APPENDIX B – ENGINEERING INFORMATION RESPONSE LETTER

PROJECT: C2122293 - 172 Glenvale Road Childcare Centre
COUNCIL REFERENCE: MCUI/2023/3954 & RAL/2023/3955

RESPONSE TO INFORMATION REQUEST – ENGINEERING ITEMS
172 Glenvale Road Childcare Centre
172 Glenvale Rd Glenvale QLD 4350

FIGURE 1 SITE CATCHMENT

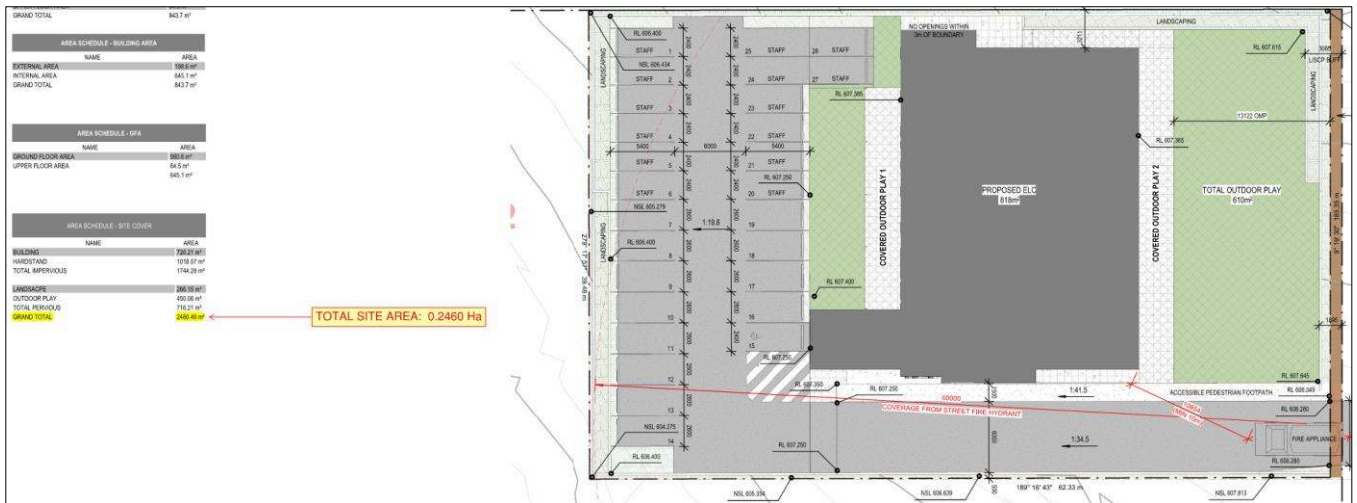
2.1 Information Required

The applicant is required to provide an amended Stormwater Management Plan, demonstrating how the proposed development will meet the stormwater quality objectives of the State Planning Policy July 2017 and demonstrate compliance with the Integrated Water Cycle Management Code and SC6.2 PSP No. 2 – Engineering Standards – Roads and Drainage Infrastructure.

The updated site area is shown in Figure 1 below. As the site is now less than 2,500sq.m the Operational Phase pollutant reduction targets set out in the SPP are no longer applicable.

The balance lot will be assessed when and if a development application is made for residential development in the future.
